Metro Gold Line Eastside Extension  
Four Quadrant Gate Feasibility Study

September 2009

**REPORT  
OF THE  
AMERICAN PUBLIC TRANSPORTATION ASSOCIATION  
FOR  
LOS ANGELES COUNTY METROPOLITAN  
TRANSPORTATION AUTHORITY  
LOS ANGELES, CA**

**REPORT OF THE  
AMERICAN PUBLIC TRANSPORTATION ASSOCIATION  
PEER REVIEW PANEL  
ON THE  
EASTSIDE CORRIDOR LRT ALIGNMENT  
OF THE  
LOS ANGELES COUNTY  
METROPOLITAN TRANSPORTATION  
AUTHORITY**

Figure 1 – No Trespass and No Vehicle Signs

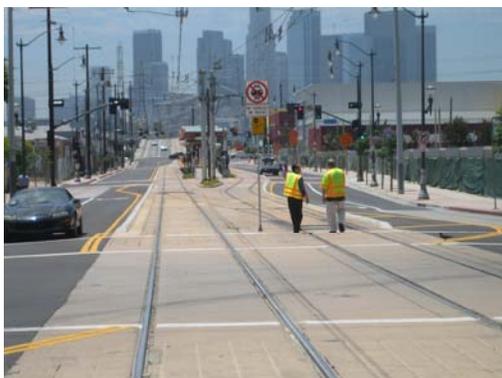
Signs have been placed within the 1<sup>st</sup> Street and 3<sup>rd</sup> Street trainways to warn pedestrians of trespass and motorists that vehicles are not permitted on the tracks. These signs are appropriate. However, the No Trespass sign size and lettering appear to be too small. The team was not able to easily read the sign until they were in the trainway itself, defeating the purpose of the sign. On the other hand the “No Vehicle on Tracks” sign and “No Vehicles” symbol sign, appear to be appropriately sized. See Figure 1

Recommendation 1 – No Trespass Signs

*Evaluate the size of, and the lettering on, the “No Trespass” signs for readability and effectiveness. The signs should be able to be read before entering the trainway.*

*Recommendation 9 – Swing Gates*

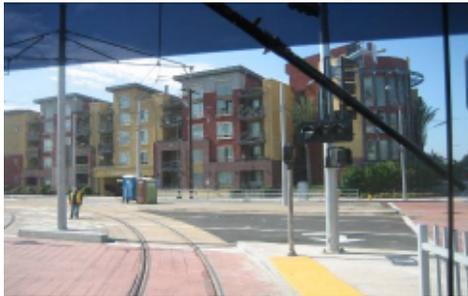
At several locations; however, the direction of the swing did not properly orient the passenger toward the approach of a train. It is recommended that each gate be evaluated for proper orientation.

*Evaluate the direction of the station swing gates to ensure that they properly orient a passenger toward the direction of an approaching train.*

**Recommendation 31– Deputy Deployment**

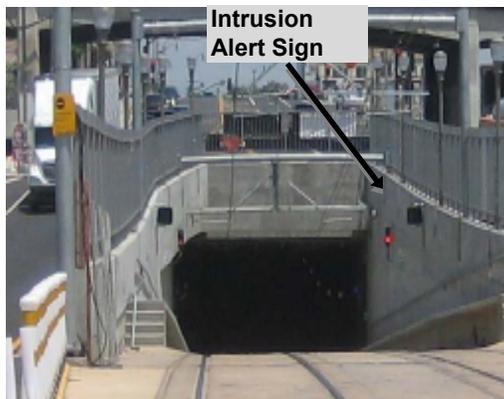
The LACMATA has contracted with the Los Angeles County Sheriff's Department to provide transit policing, security, and fare inspection services throughout the Metro service area. At the start of revenue service, two additional transit police deputies will be assigned to patrol the Eastside Extension. The planned deputy deployments do not appear to be sufficient.

*Evaluate current plans for deputy deployments. Consideration should be given to expanding police coverage by adding 6 or 8 additional personnel on trains, complemented by mobile units.*
